SERVICE BULLETIN

RS 344
February 2003

| MODEL | SUBJECT |
|--|-------------------------|
| EH65, EH64, EH65 EH63V, EH65V, EH72 | Change of Ignition Coil |

• **DETAIL OF THE CHANGE:**

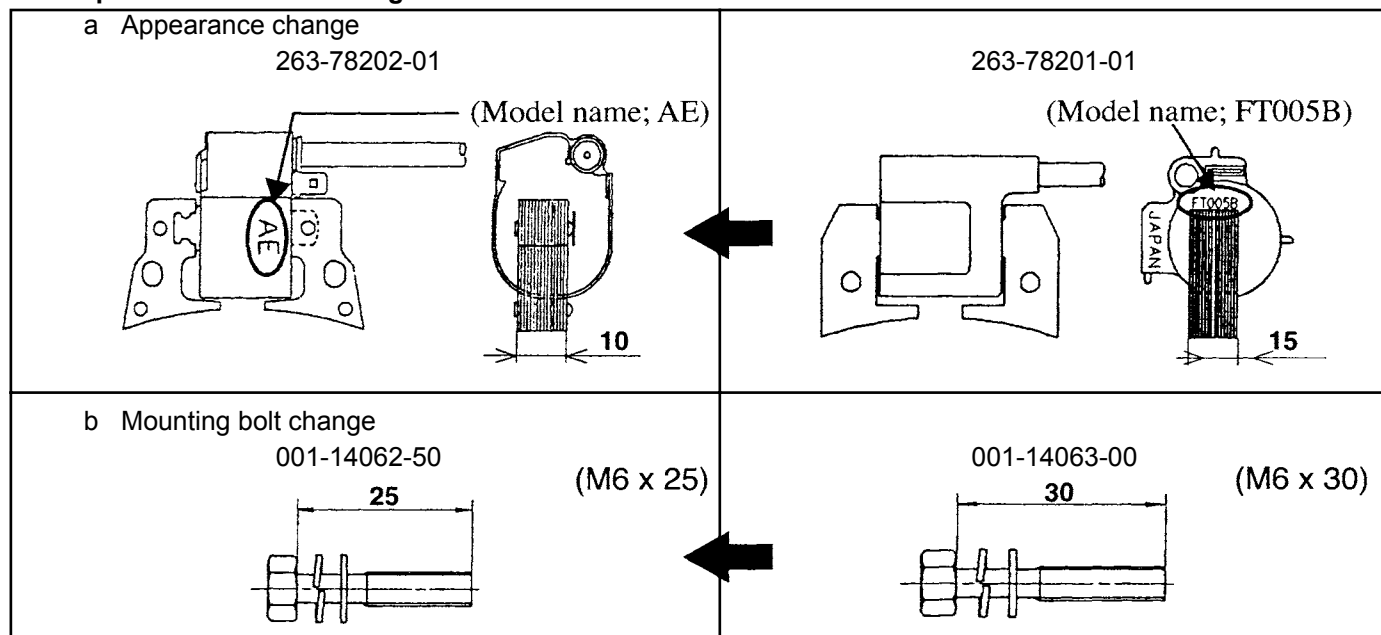
- **PURPOSE:**
Change in coil manufacturer (1) and start-ability improvement (2)
- **AFFECTED PRODUCTS:**
All specifications (except for Onan) of EH64, EH65, EH63V, EH65V and EH72
- **DETAIL OF CHANGE:**
Refer to page 2
- **CHANGE OF PART NUMBERS and INTERCHANGEABILITY:**

After the Change

Before the Change

Step 1. Manufacturer change

Step 2. Start-ability improvement

| No | Description | After the change | | Interchangeability | | Before the change | |
|----|------------------|------------------|-----|--------------------------------|---------------|-------------------|-----|
| 1 | Ignition Coil | 263-78202-01 | 2 | No New ← X → Old | New ← ○ → Old | 263-78201-01 | 2 |

| No | Description | After the change | | Interchangeability | Before the change | |
|----|---------------|------------------|-----|--------------------------|-------------------|-----|
| 1 | Ignition Coil | 263-78202-11 | 2 | New ← X → Old | 263-78202-01 | 2 |

| <p>263-78202-11</p> <p>Product Lot NO;</p> <ul style="list-style-type: none"> • 29X thru 2C5 (with white paint) • 311 and after (without white paint) | <p>263-78202-01</p> <p>Product Lot NO;</p> <ul style="list-style-type: none"> • Up to 29X (without white paint) |
